BUILDING PERMIT

Located At 74 MCKINLEY CT

Job ID: 2011-06-1278-MF 3

Building Permit Application Project Description

ATTACHMENT 7

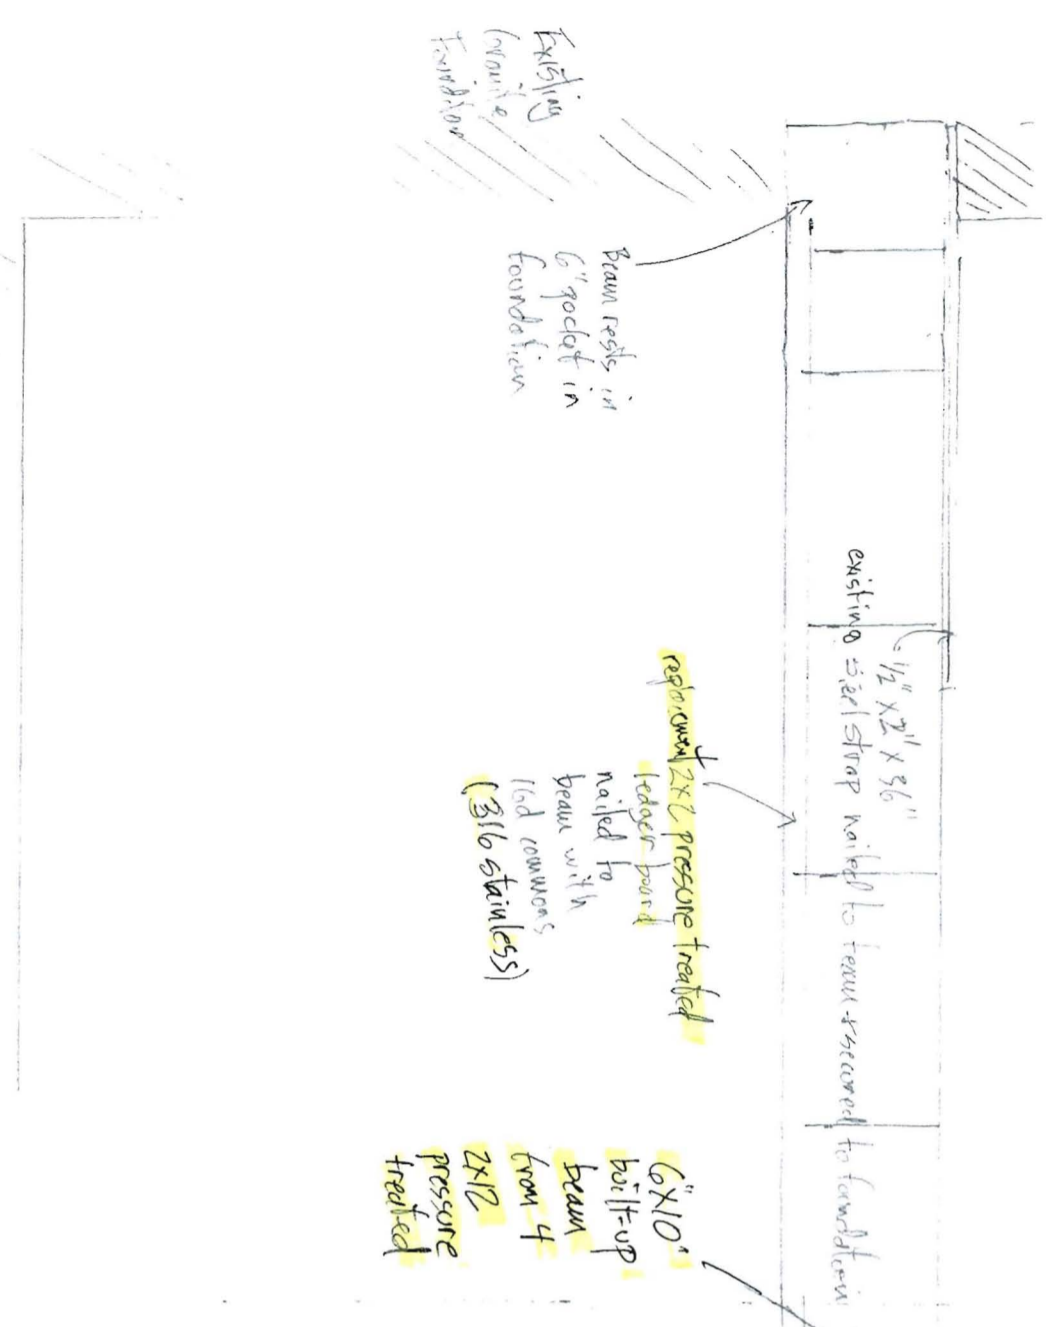
ok
per
Tom
Cucke
6/24/14
JMB

ATTACHMENT 5

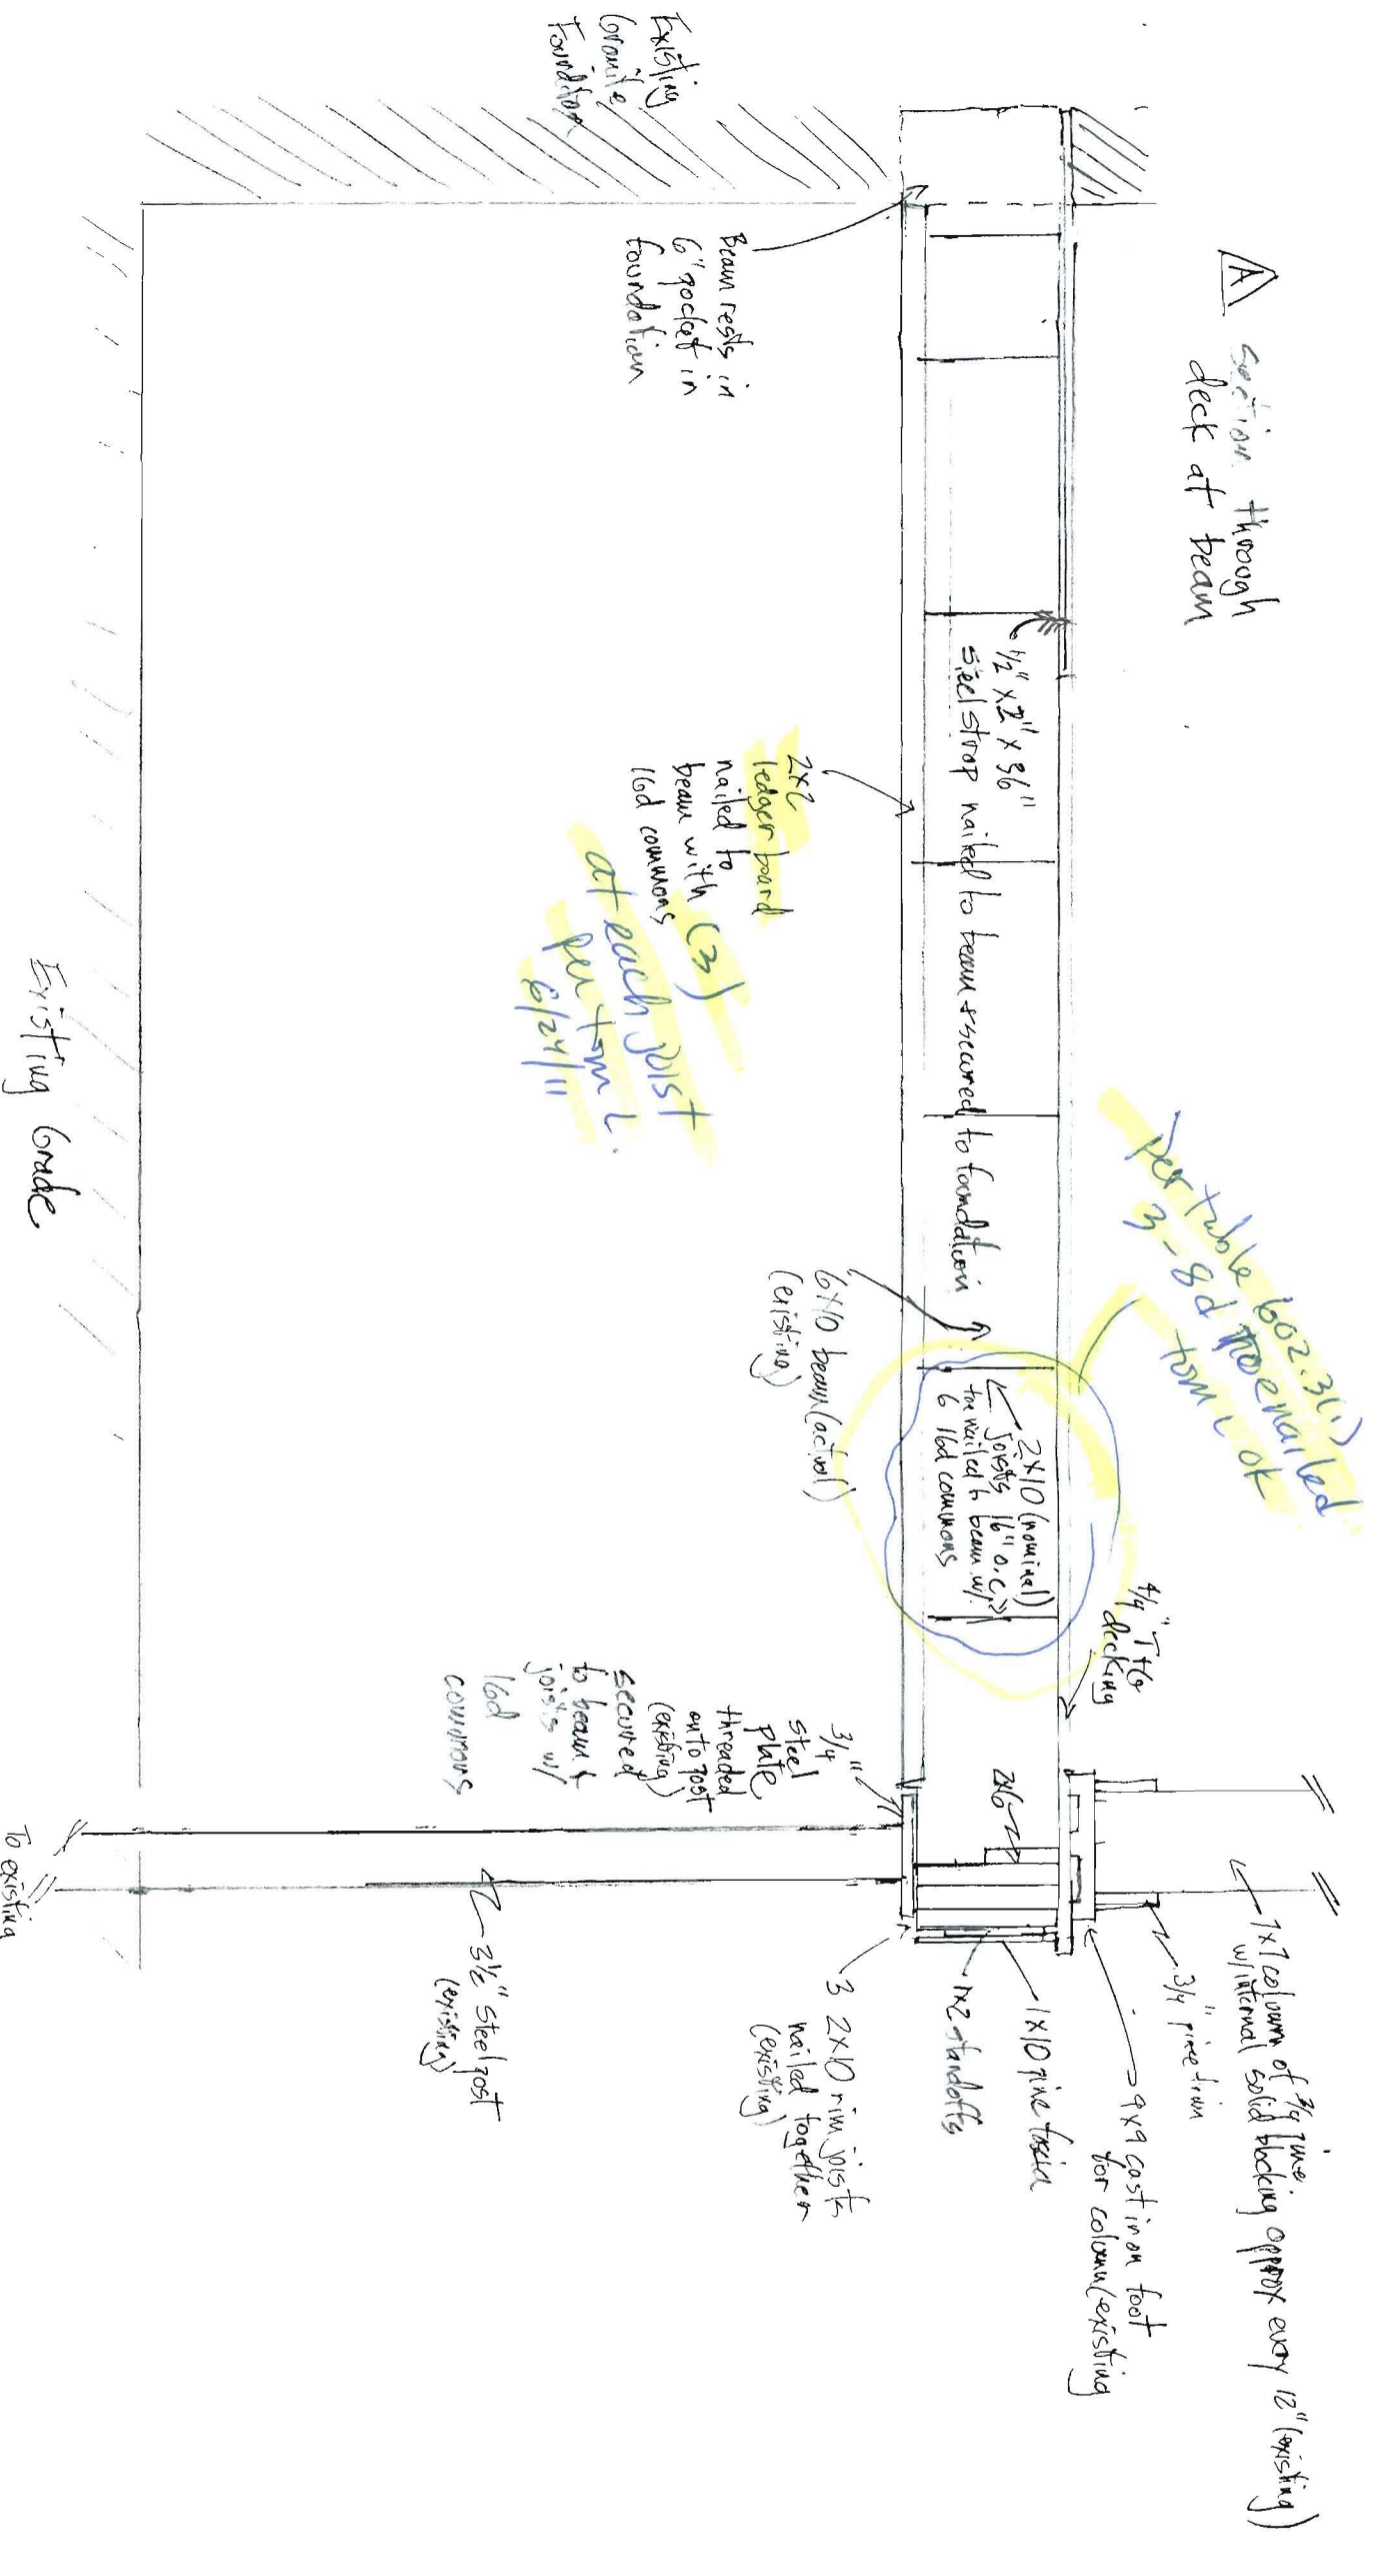
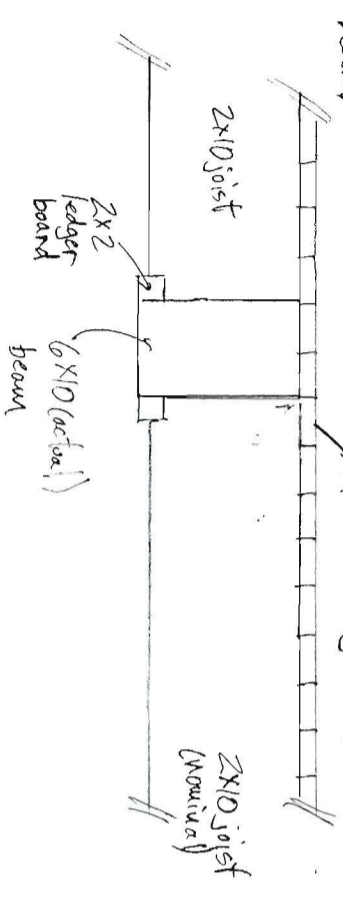
Beams rest in 6" deep ~~for~~ ^{Per Bml. 6/29/11} will protect w/ tan paper (actual 1/4" PT)
